- fpn 429823-1 is a shared use path in name only because the project has cumulative design variations from the FDOT Design Manual (FDM). One of many design variations from FDM is to reduce the top speed to only 10 mph. That one design variation alone renders the project not useable for the intended purpose.

**4.7 mile long Multi Use Trail proposed along North side of SR80  
Fpn 429823-1**

**4.7 mile long Sidewalk Proposed along the South side of SR80. fpn 435341- 1**  
**Most Businesses/Pedestrian Generators along the South side use Shared Access Points.**

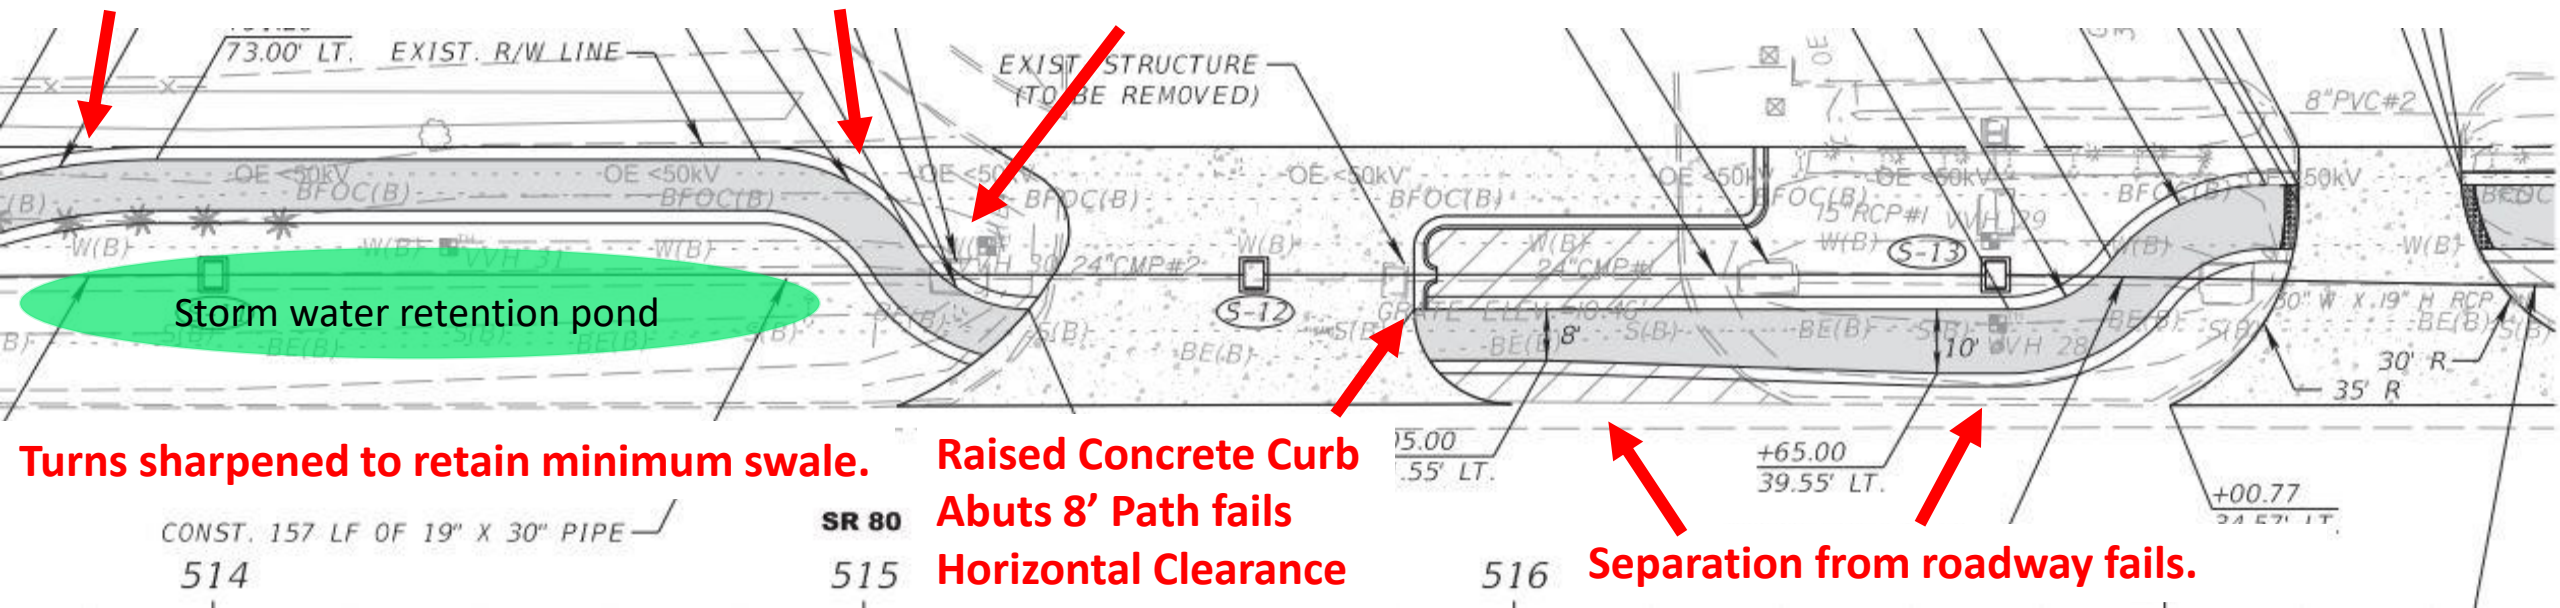
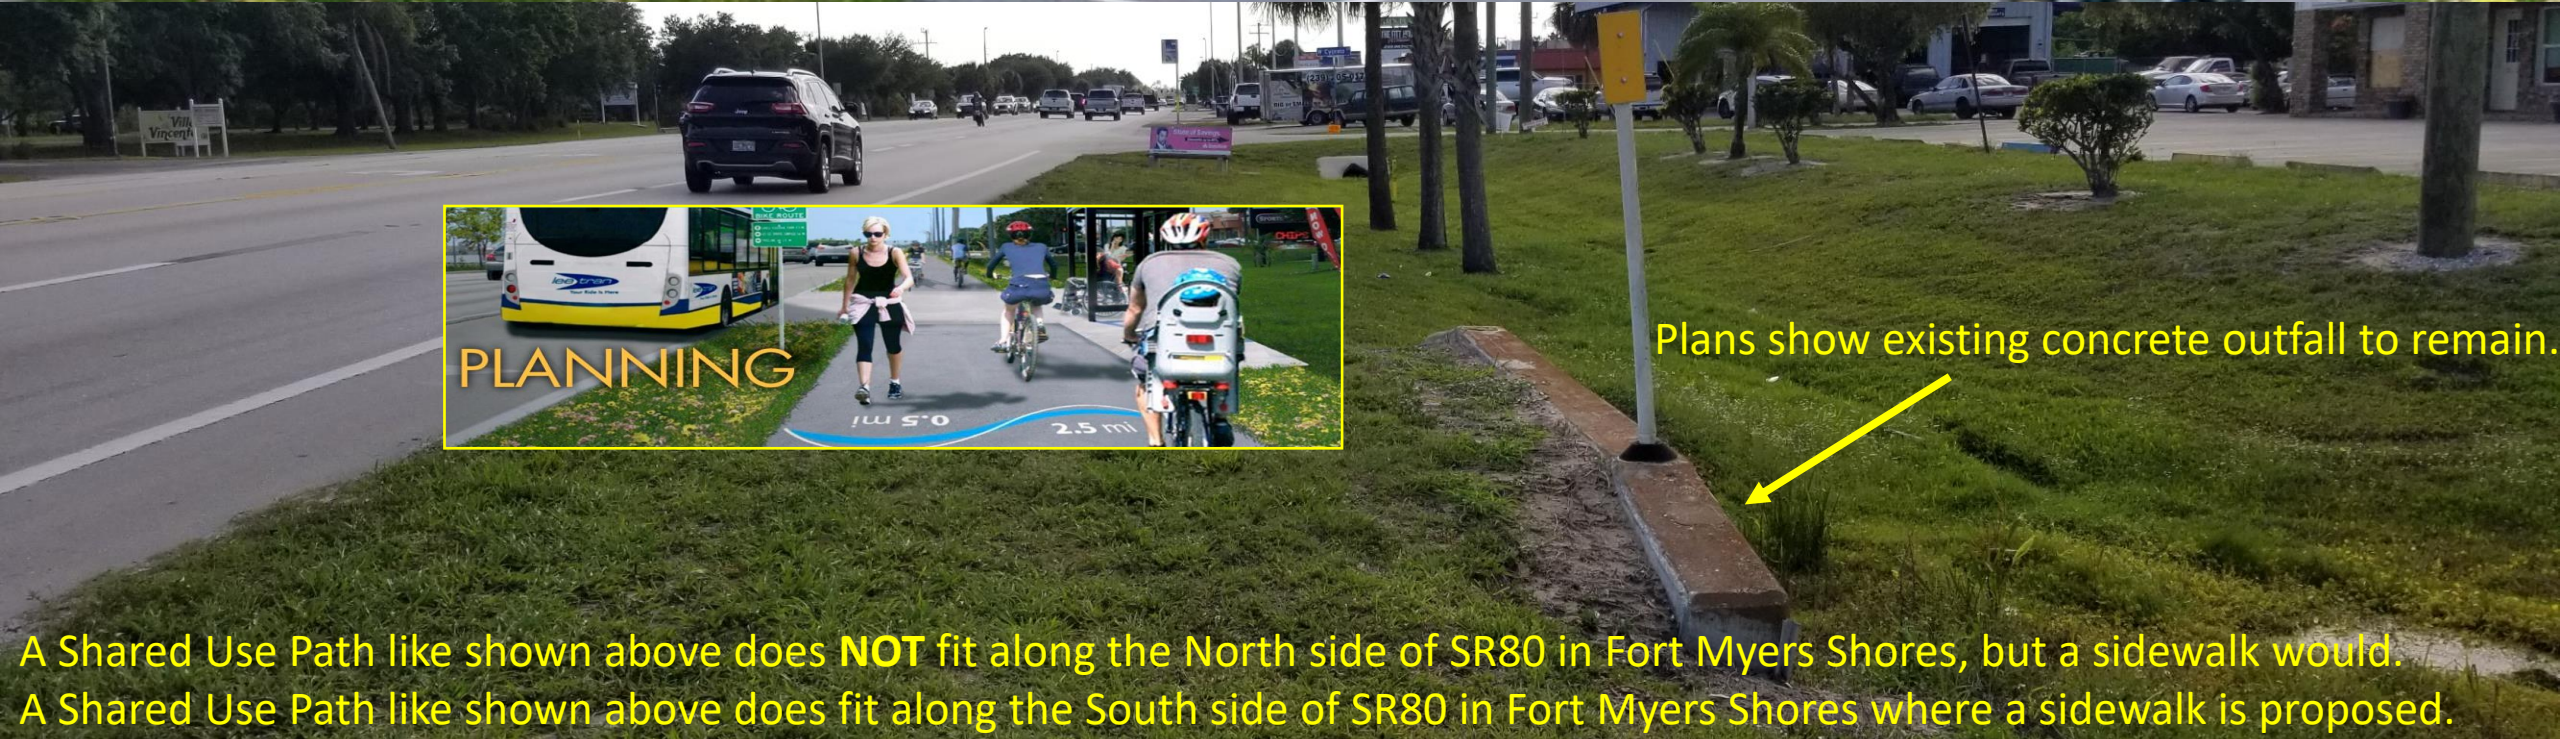
**Above image was a conceptual design for 10' wide Multi Use Trail along the North side.**

**The bottom image is reality of the same road sections after recent revisions on 5-15-20.**

**Width reduced to non-conforming 8' wide**

**Curve fails FDM by more than 4 times the FDM Minimum Radii.**

**There's not enough area to construct a Reduced Width Multi Use Trail, especially at the expense of giving up on ever constructing a Trail along the South side. A 6' to 8' wide Concrete Sidewalk is the only prudent option for the North side. Then we can request a 10' to 14' Multi Use Trail along the South side.**

(Sections below are all only 8' wide and abut SR80)

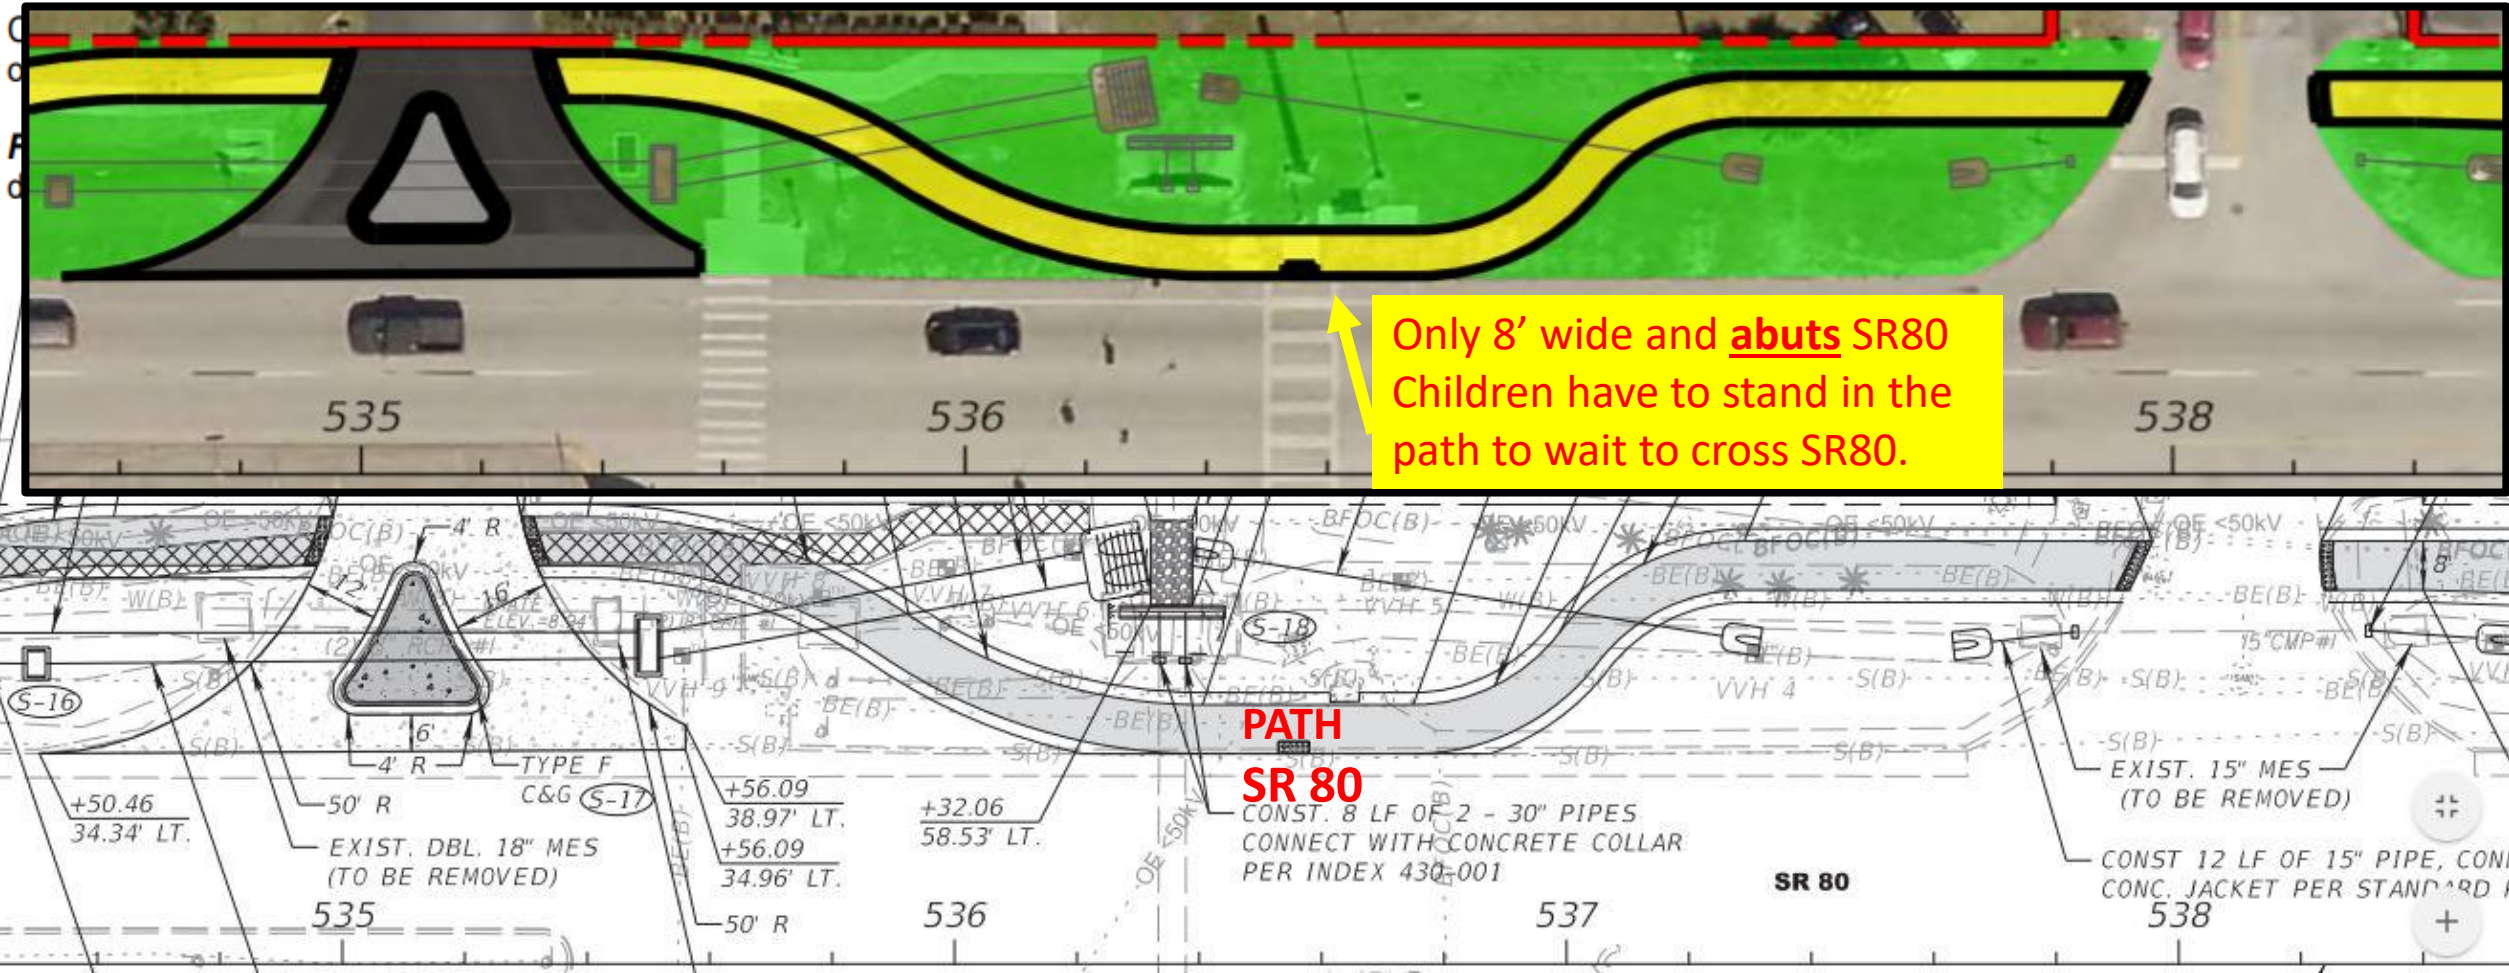
**MORE LINEAR FOOTAGE IS ONLY 8' WIDE THAN 10' WIDE.**

- 10-foot wide may be used where there is limited R/W.
- Short 8-foot wide sections may be used in constrained conditions.

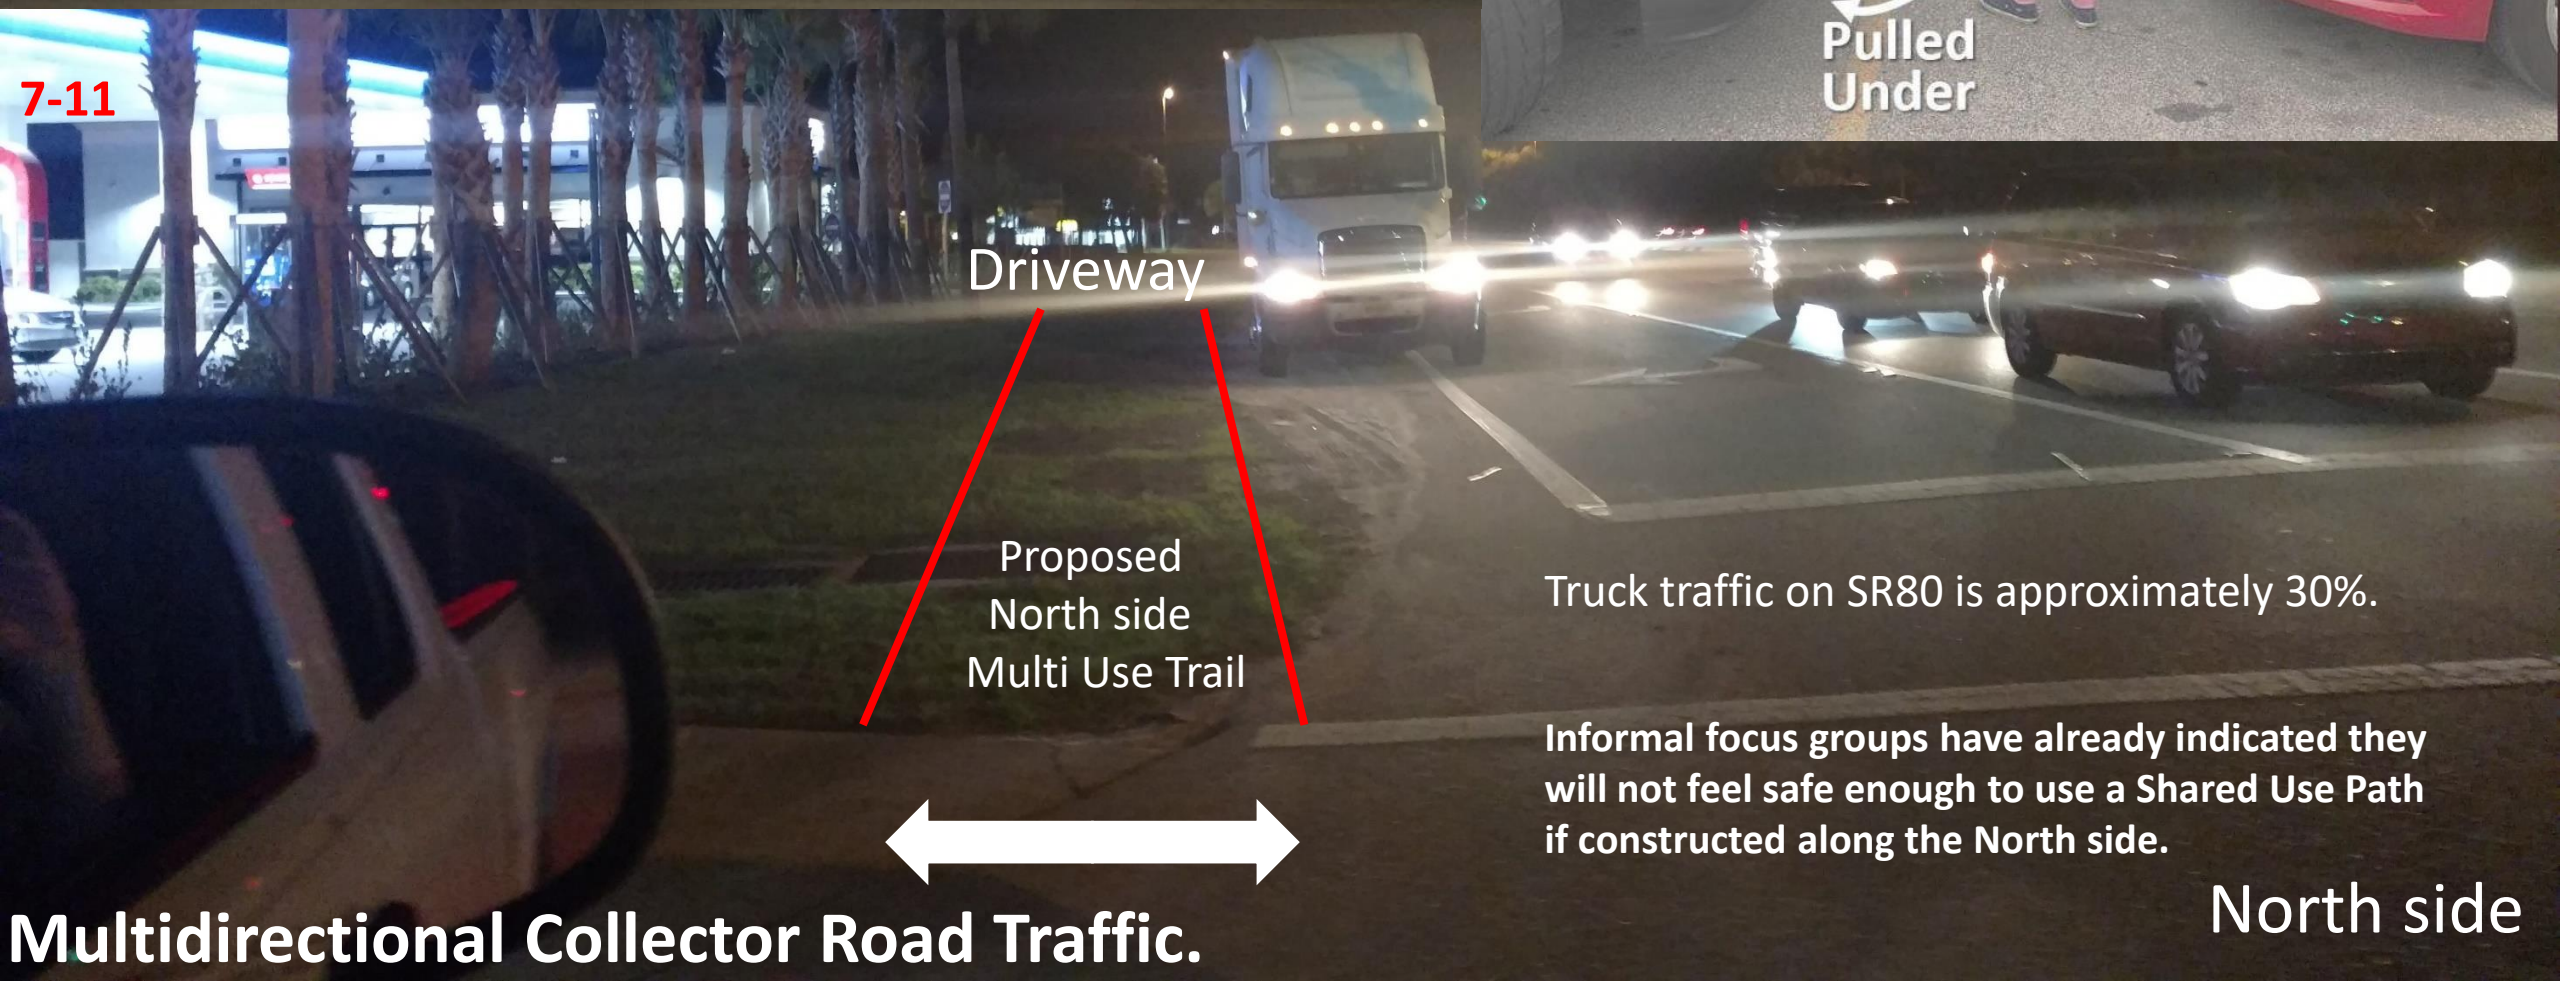
In only half a block there are *seven* driveways on the north side...

...and *zero* driveways on the south side.

An *eight* proposed Driveway Connection.

A ten to one (and rising) Conflict Point ratio from the North side of SR 80 to South side of SR 80 disqualifies the North side for a Shared Use Path.

The North side places the Path too close to the road.

South side provides Shade and Separation from the Roadway.
